California Independent  
System Operator

**Subject: South Bay Re-Power Generation Interconnection Facility Study Review**

## **ATTACHMENT**

South Bay Re-Power Interconnection

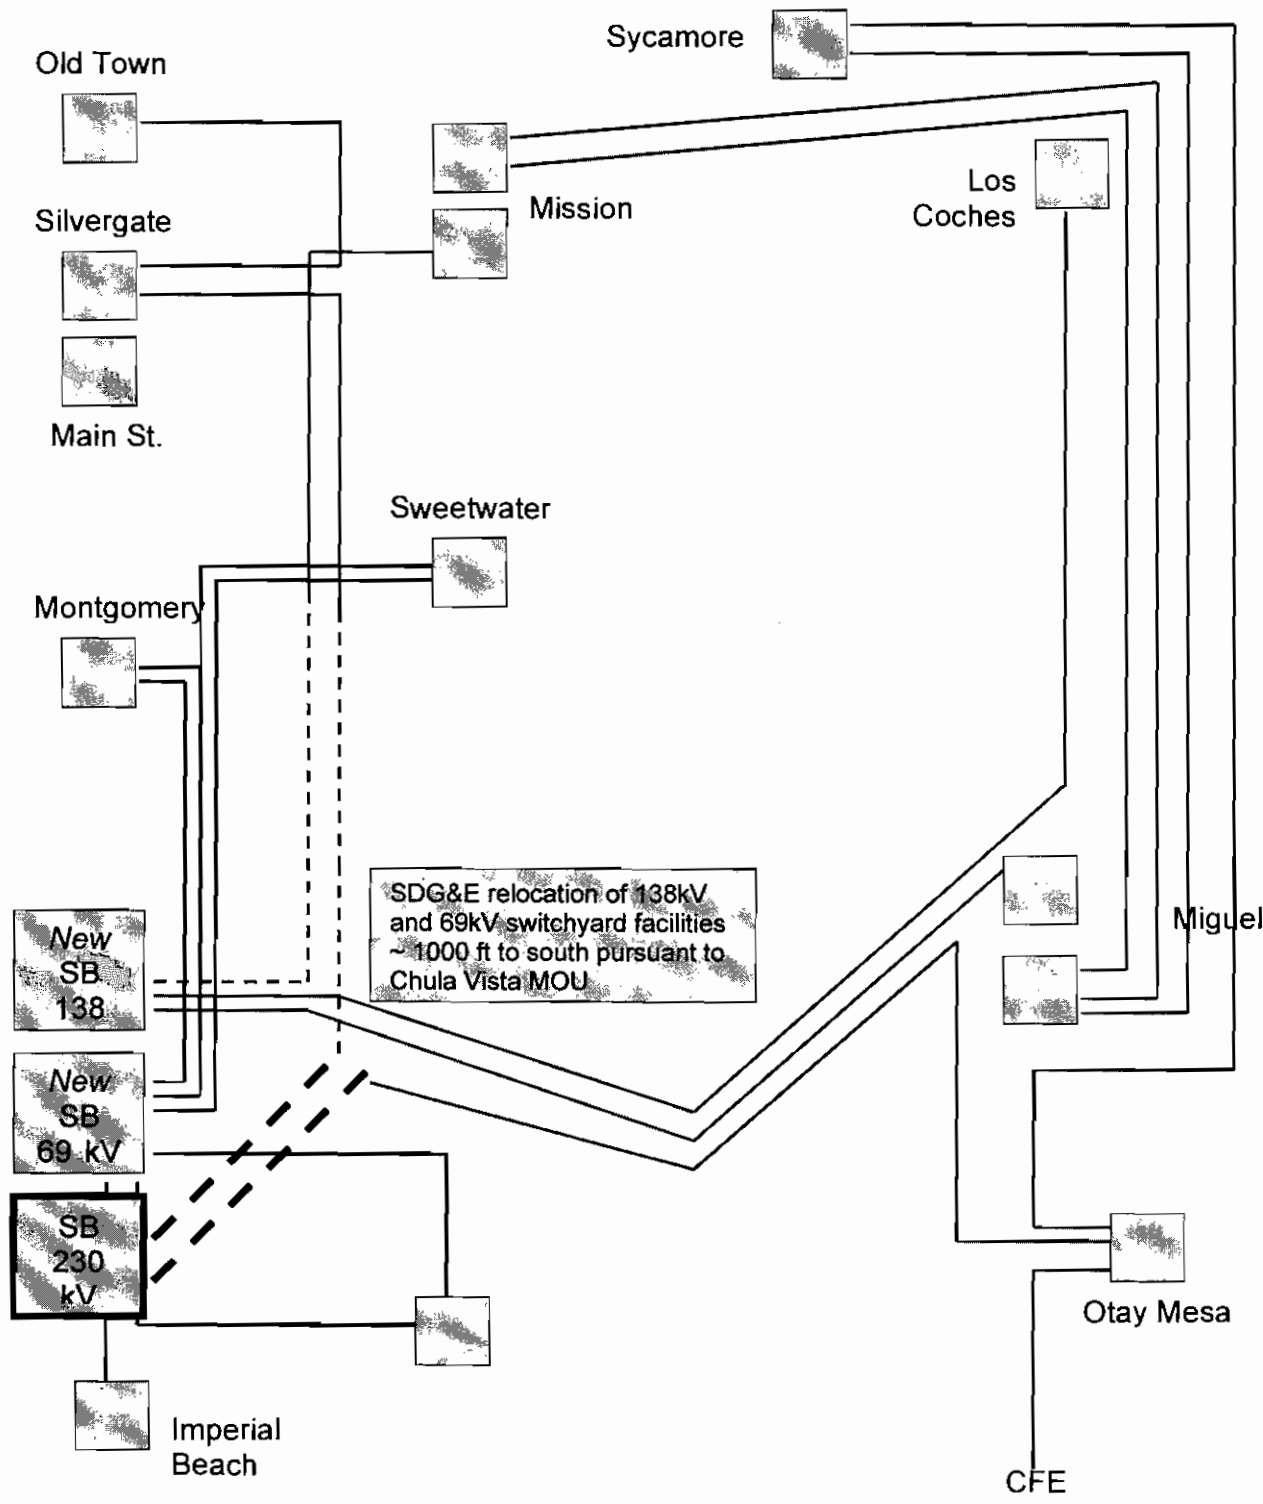
3. The report included design of the new South Bay Substation layout. The initial design included an additional circuit breaker for one new 69 kV transmission line. The ultimate design included two additional circuit breakers for 230 kV transmission lines, another circuit breaker for a second new 69 kV line and one additional circuit breaker for a 138 kV transmission line. These extra line positions add to the size of the substation. More details need to be provided on how SDG&E intends to use these circuit breaker positions and what future needs these additional lines will satisfy.
